Sumter City-County Planning Commission

MSP-13-34 & HCPD-13-16, Willie Sue's at Patriot Centre (City)

Applicant:	Scott Bell, RS Bell Architects, LLC
Status of the Applicant:	Project Architect
Request:	Major site plan and highway corridor review for a proposed 6,240 sq. ft. restaurant.
Location:	Patriot Centre, northwest corner of the intersection of Patriot Parkway and Loring Mill Road.
Size of Property:	+/-1.315 acre outparcel within larger development
Present Use:	Undeveloped
Zoning:	PD-00-08, Sumter West Planned Development
Proposed Use:	Full Service Restaurant
Tax Map Reference:	185-00-01-038 (Part)

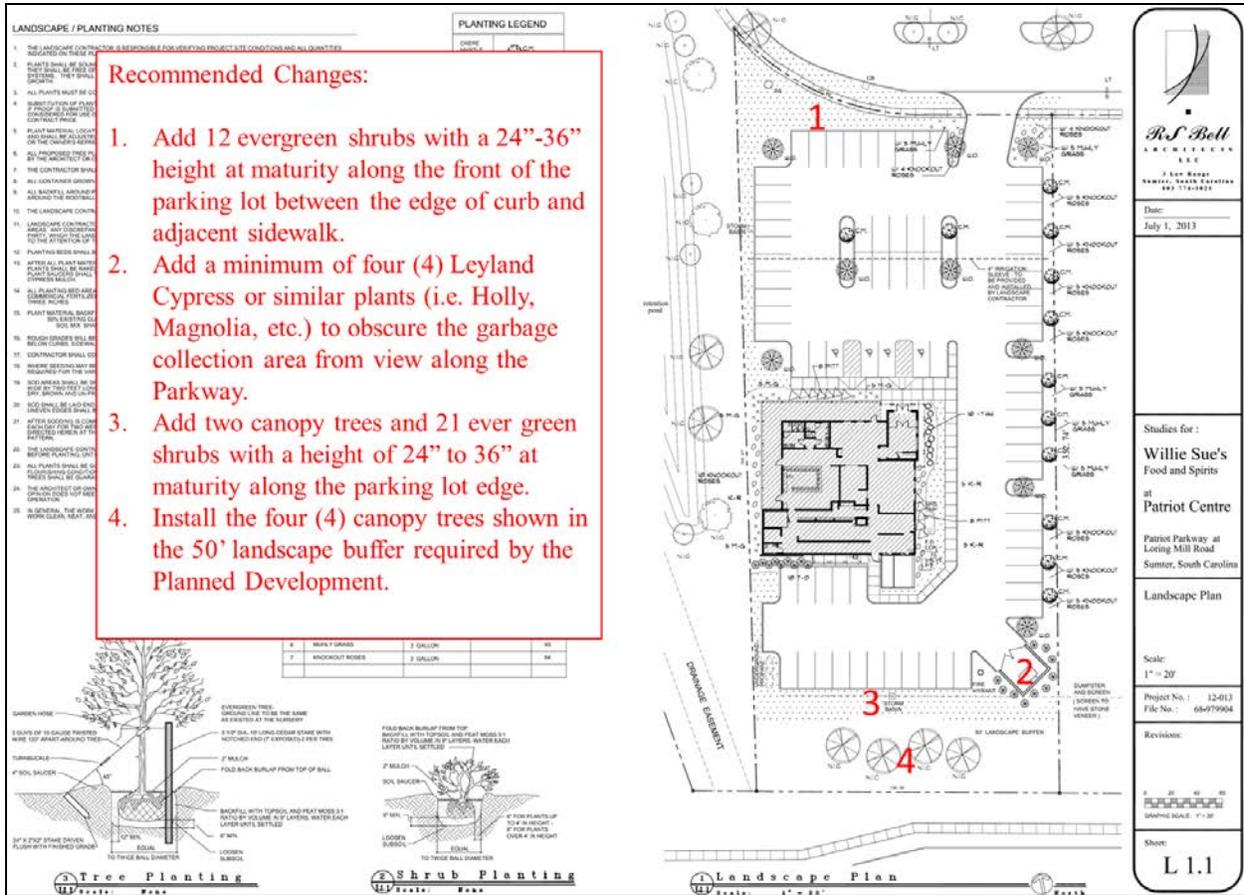
A full set of civil plans are under development. The applicant has requested approval contingent upon submission of full civil plans that reflect the architectural site plan.

The architectural site plan shows a 6,240 sq. ft. restaurant building with 76 parking spaces. Restaurants are required to have 1.2 parking spaces per 100 sq. ft. of gross floor area, based on Ordinance standards the site must provide at minimum 75 parking spaces. The submitted plan meets the required number of parking spaces.

The site plan meets all required setbacks and bufferyard widths however; there are four items that must be addressed with the landscape plan.

Outparcel A, the proposed development site drains to “Detention Pond 2” that has already been constructed. Based on approved plans and calculations, each outparcel was assumed to have no more than 80% impervious surface. Based on the submitted architectural site plan, the site is 68% impervious. This number will be verified upon receipt of full final civil plans.

Contingent upon submission of a revised landscape plan addressing the deficiencies outlined in the landscape review and submission of full civil plans that reflect the submitted architectural site plan, Staff recommends approval.

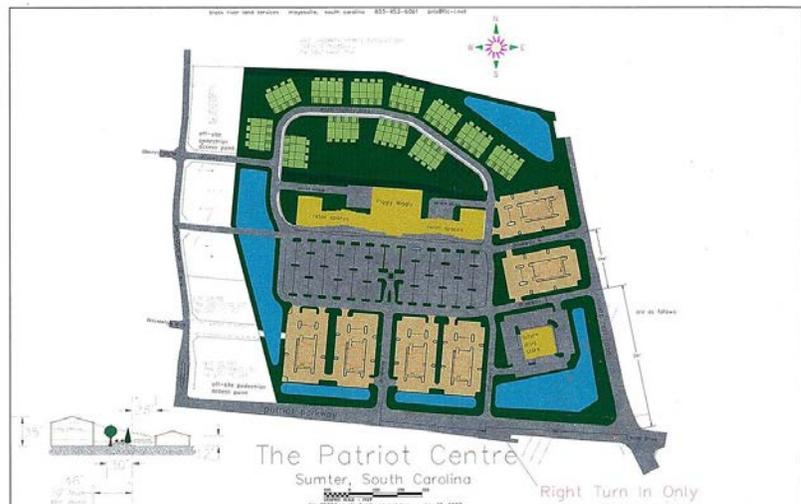
A Traffic Impact Study was submitted in 2008 when the Patriot Centre was first approved. As part of the retail center's development plan, overall site access was approved based on the access drives shown in the graphic to the right.

Each outparcel gains access to Patriot Parkway and Loring Mill Roads from the access points shown in the approved Patriot Centre concept plan. Initially, site development was to proceed with the construction of all access infrastructure and development of the 85,000 sq. ft. retail anchor structure however, construction halted after all of the utility infrastructure and some of the road beds were installed, prior to any site paving.

As shown in the graphic below, the closest access point to the proposed outparcel is the full access drive on Patriot Parkway.

The area shaded in yellow is the most logical route for access to the development site. Planning Staff recommends that this portion of the internal shopping center road network highlighted above be installed prior to issuance of a Certificate of Occupancy for the proposed restaurant. In addition, interparcel pedestrian access is a requirement of this planned development. As such, the sidewalk, indicated as a bold yellow-orange line in the graphic must also be installed to meet the requirements of the planned development.

It should be noted that future development within Patriot Centre will trigger the requirement for additional transportation infrastructure installation including additional sidewalks, and installation of deceleration and turn lanes as this entrance.

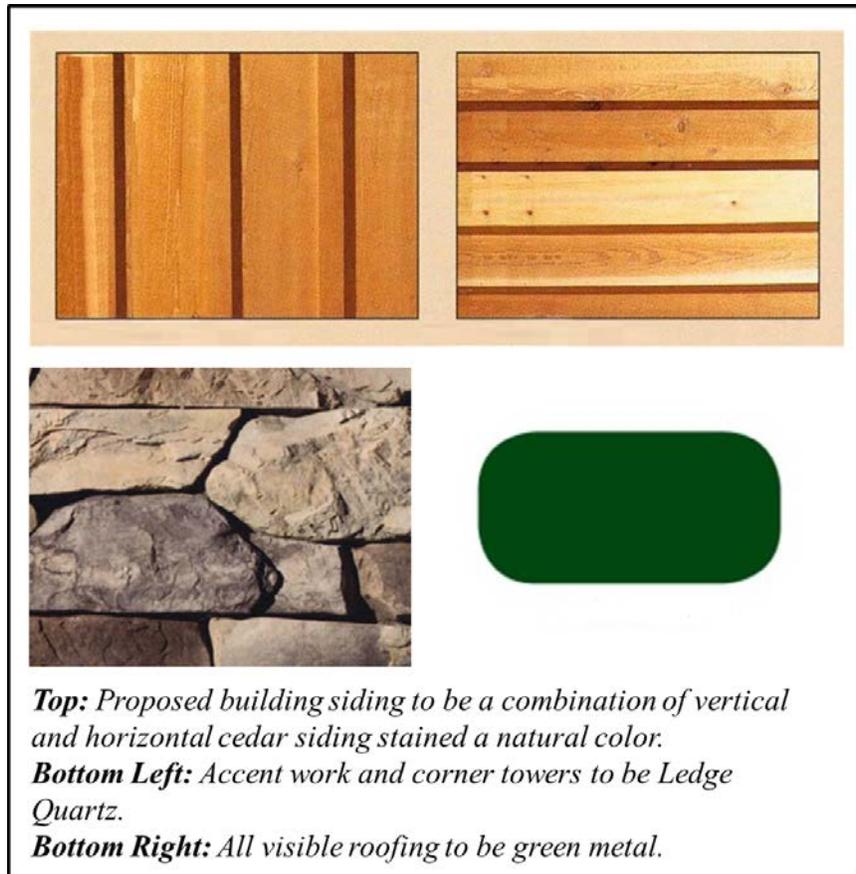
The site is new construction. As shown in the renderings below, the proposed exterior materials will be predominantly cedar siding with ledge quartz veneer and green metal roofing. The following 3D renderings show all four sides of the proposed building.

The Planned Development does not allow individual freestanding signs for each outparcel. The structure is permitted to have a maximum of two wall signs. The combined area of the wall signs is not to exceed 15% of the front wall area of the structure. Architectural renderings show wall signage however actual sign area has not been calculated—signs shown on the rendering may be required to be smaller than proposed in order to meet standards.
